Attention: Development Assessment
MODIFICATION APPLICATION: MOD 2019/0029 DA367/2010
46 Victoria Parade Manly 2095 NSW

MODIFICATION APPLICATION: MOD 2019/0029 DA367/2010
46 VICTORIA PARADE, MANLY

OBJECTIONS FOR THE ABOVE MODIFICATION

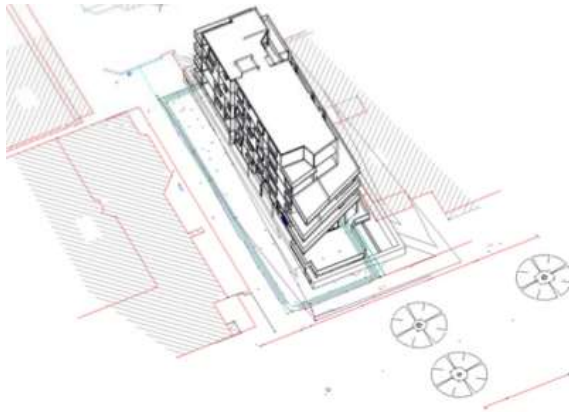
i) IMPLICATIONS OF CHANGE TO ROOF PROFILE APPROVED BY LEC AND MIAP

There is no justification for the change in the design of the roof as approved by the LEC and MIAP on 21st August 2014. Our owners had to spend considerable time, effort and money in order to receive a fair outcome to prevent overshadowing of our building.

The roof plan, S96:200 of the 2014 DA was redesigned again on 28 May, Issue C, in order to provide sunlight to specific areas, reduce the effect of overshadowing and limit the potential of slippery pathways and fungus growth through lack of sunlight. This new DA still reduces sunlight to the Ground, and Level 1 of our building.

View plane - aligned balconies

The ARC Drawing for the roof does not match this screenshot taken from the SEPP65 Statement. There seems to be inconsistency with the screenshot showing the 'cutout' towards the rear of the building and with angles, and the 'cutout' shown in the ARC Roof Plan Issue E for this modification showing straight lines.

There is considerably less "cutout" in the Arc Drawing than that shown in the MIAP approved 2014 roof "angled roof cutout" and the open balcony on Level 4 (Drawings 201 and 200 Issue C dated 28 May 2014) submitted by Design Cubicle.
